Addendum	
Addendum – RFQ-CC-2025-01 Accessible Door Upgrades at Best and Bash Arena	
Providing pictures and measurement of each door.

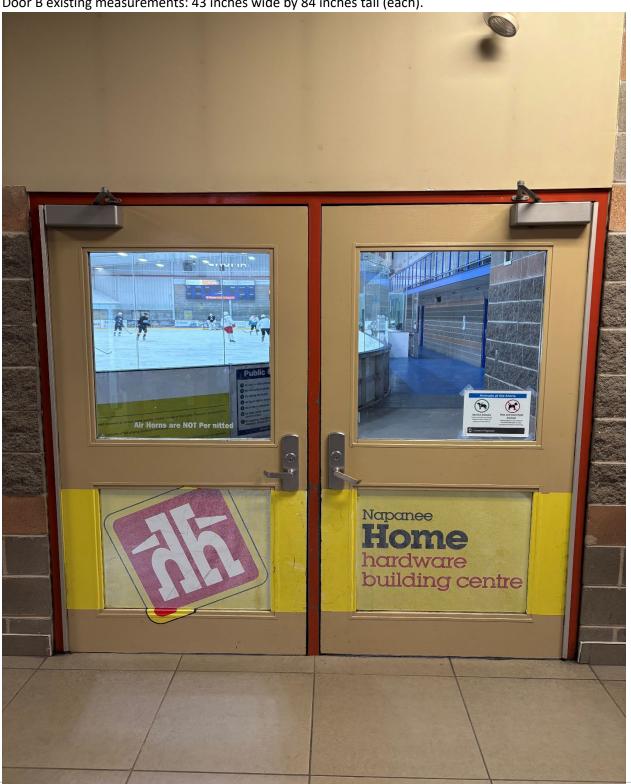
Can you please provide each door measurement and photos?

Door A existing measurements: 43 inches wide by 84 inches tall (each)

Door B existing measurements: 43 inches wide by 84 inches tall (each).

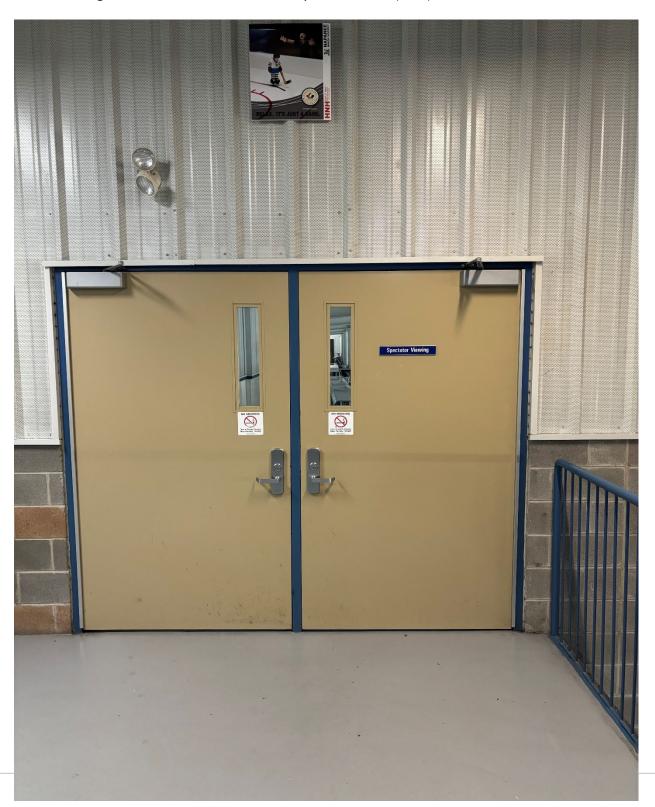
Do all doors currently have operators/power supply? Can you provide photos of existing doors? Can you provide size and finish of the new hollow metal door?

Only the banquet hall door has an operator/power supply. All other doors DO NOT. See addendum for photos of all existing doors. The new door required for Door D – Upper Level Seating (Home) will be 38 inches wide by 84 inches tall. As seen in the photo below, the frame is 54 ¾ inches wide and 107.5 inches tall. It will require sidelite and transom. The new hollow metal door will be primed finish. Town staff will paint after install.
